SUBJECT: NuScale Power, LLC Response to NRC Request for Additional Information No. 296 (eRAI No. 9231) on the NuScale Design Certification Application

REFERENCE: U.S. Nuclear Regulatory Commission, "Request for Additional Information No. 296 (eRAI No. 9231)," dated December 13, 2017

NuScale Response to NRC Request for Additional Information eRAI No. 9231

Figure 5.4-4: Integral Steam Plenum

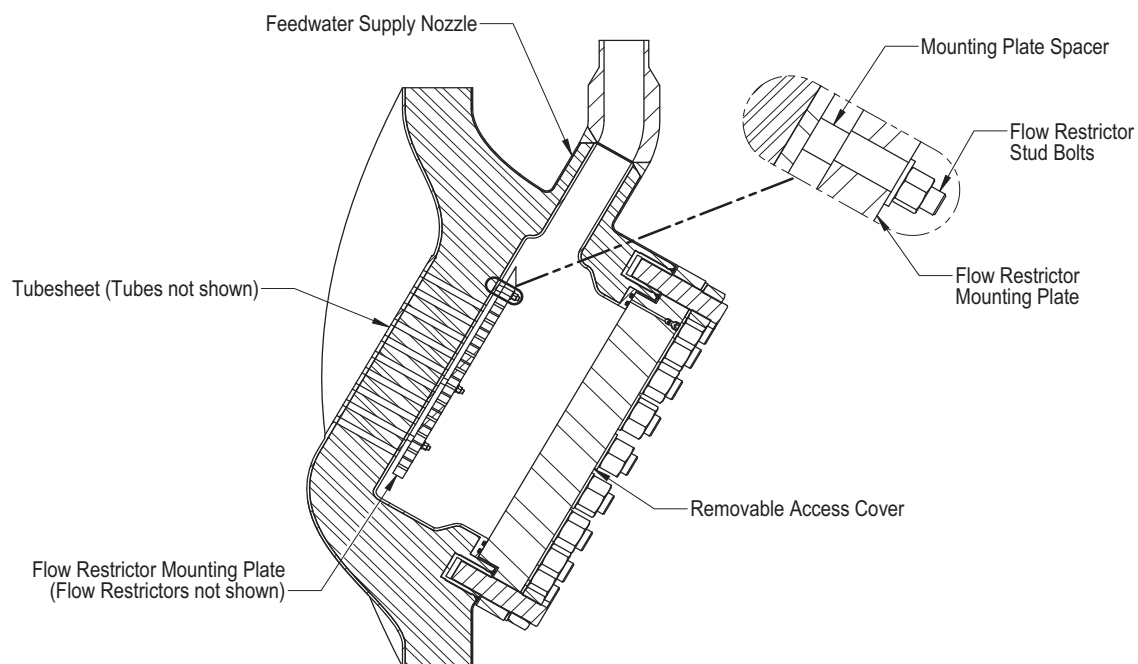
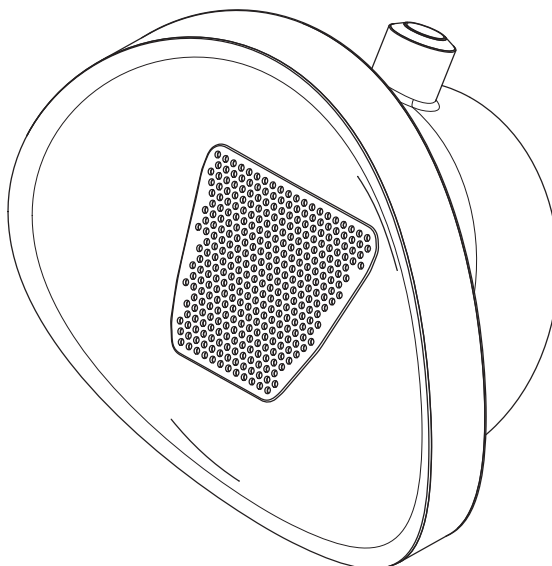
NRC Question No.: 05.04.02.01-5

- a. A statement that the steam generator system (SGS) also includes the main steam and feedwater supply nozzles has been added to FSAR Section 5.4.1.2. All SGS components and the associated classification designations are also provided in FSAR Table 3.2-1.
 - b. The main steam and feedwater nozzles have been identified on FSAR Figures 5.4-4 and 5.4-5, respectively.
 - c. A statement of the location of the main steam and feedwater supply nozzles has been added to FSAR Section 5.4.1.2.
-

- d. The main steam and feedwater nozzles are integral to the steam plenum access ports and feed plenum access ports, respectively (i.e., there are no welds between the nozzles and the associated access ports). This information has been added to FSAR Section 5.4.1.2. Steam and feed plenum access port materials are listed in FSAR Table 5.4-3.

FSAR Section 5.4.1.2, Figure 5.4-4 and Figure 5.4-5 have been revised as described in the response above and as shown in the markup provided in this response.

Figure 5.4-6: ~~Steam Generator Tube Support Bars and Cantilevers~~ Steam Generator Tube Supports and Steam Generator Supports

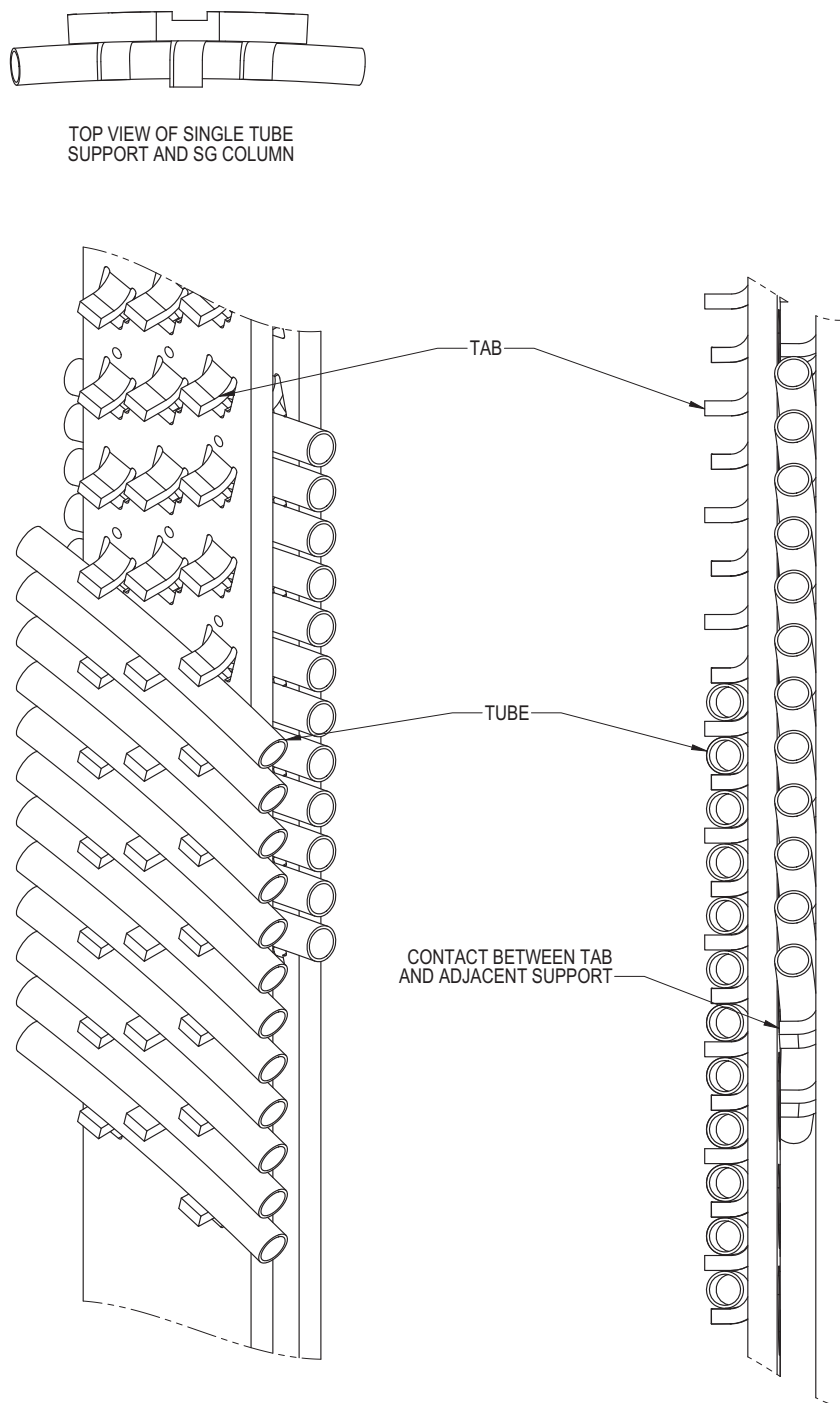
- c. Table 5.2-7, "Reactor Vessel Internals Inspection Elements," and Figure 5.4-7, "Steam Generator Tube Support Tabs," in Tier 2 of the FSAR refer to plates. Given that the FSAR states that tube support plates used in the currently operating fleet are not used in the NuScale design, please confirm that the "plates" referred to in this table and figure are the vertical support bars and revise this table and figure to that effect.

- c. The steam generator tube support design has been modified, including changes in terminology, to align with the CVAP. As part of the design change, naming of some tube support components has changed, including use of the term “tube support plates,” which has been removed. There are no structures in the NuScale design that are comparable to “tube support plates,” (i.e. solid metal plates with drilled holes that the tubes pass through) as they exist in currently operating commercial SGs. The design changes implemented are limited to features related to manufacturing details (e.g. specific placement of welds, method of forming specific geometric features, etc.) of the SG tube supports. The interface between the tubes and the supports, the general structural design and the overall function of the supports is unchanged.

FSAR Sections 3.2.2, 3.9.3.1.2, and 5.4.1, FSAR Figures 5.4-6 and 5.4-7, and FSAR Tables 3.2-1, 5.2-4, 5.2-6, 5.2-7, and 5.4-3 have been revised to reflect the updated design of the steam generator tube supports including revised language used to describe the steam generator tube supports and the upper and lower steam generator supports.

The SG tubes are supported for vibration and seismic loads by vertical bars that extend through the tube bundle from the feed to the steam plena. As shown on Figure 5.4-6, the ~~vertical~~ tube support ~~bar~~ assemblies are attached to upper ~~tube support bars~~ SG supports that are welded to the inner surface of the RPV and also interface with lower ~~tube support cantilevers~~ SG supports that are welded to the inner surface of the RPV. The SG tube support ~~bar~~ assemblies in the SG provides contact with each tube at eight separate circumferential locations. The use of 8 sets of tube support ~~bar~~ assemblies limits the unsupported tube lengths, which ensures SG tube modal frequencies are sufficiently high to preclude unacceptable flow-induced vibration.

~~lateral restraint for the support bars.~~ As shown in Figure 5.4-6, the lower SG supports permit thermal growth and provide lateral support of the tube supports.

Figure 5.4-5: Feedwater Plenum Access Port**FEED PLENUM ACCESS PORT CUTAWAY**

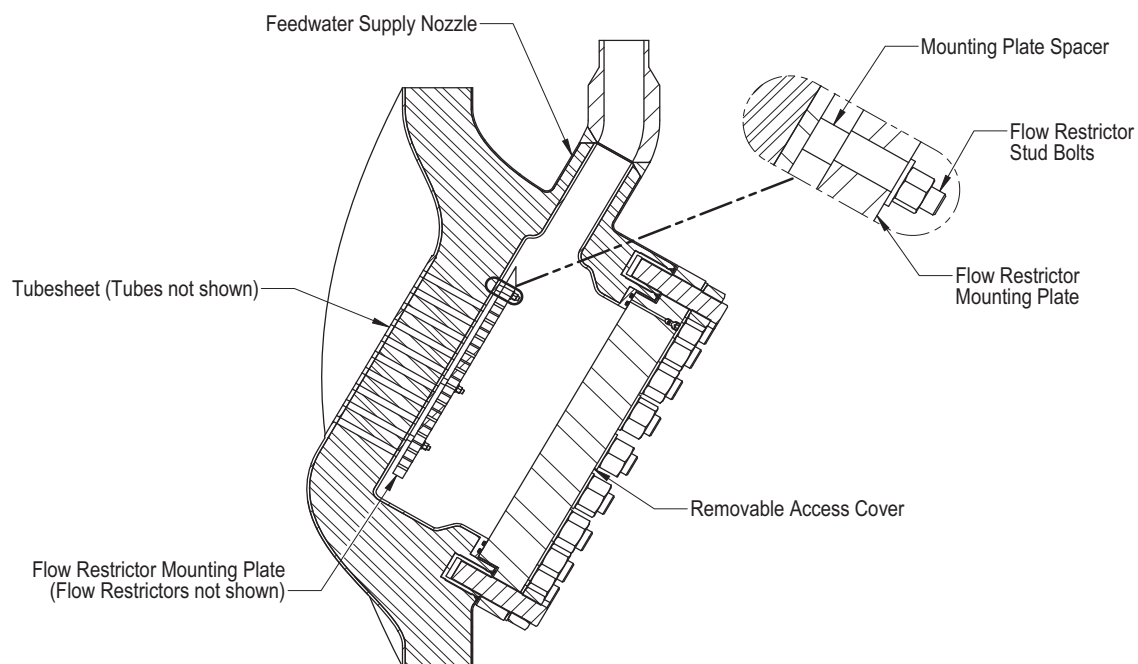
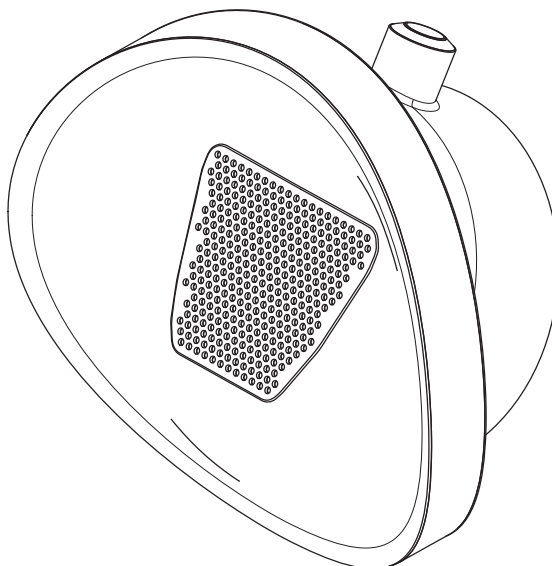
- c. Table 5.4-3 in Tier 2 of the FSAR includes components called “flow restrictor bolts,” “flow restrictor stud bolts,” and “flow restrictor mounting plate spacer.” Revise Figure 5.4-8 of Tier 2 of the FSAR to clarify their location and revise Section 5.4.1.2 in Tier 2 of the FSAR to clarify their functions.
-

- c. FSAR Figures 5.4-5 and 5.4-8 and FSAR Section 5.4.1.2 have been revised to clarify the location and function of the “flow restrictor bolts,” “flow restrictor stud bolts,” and “flow restrictor mounting plate spacer.”

FSAR Section 5.4.1.2, Section 5.4.1.5, Figure 5.4-5 and Figure 5.4-8 have been revised as described in the response above and as shown in the markup provided in this response.
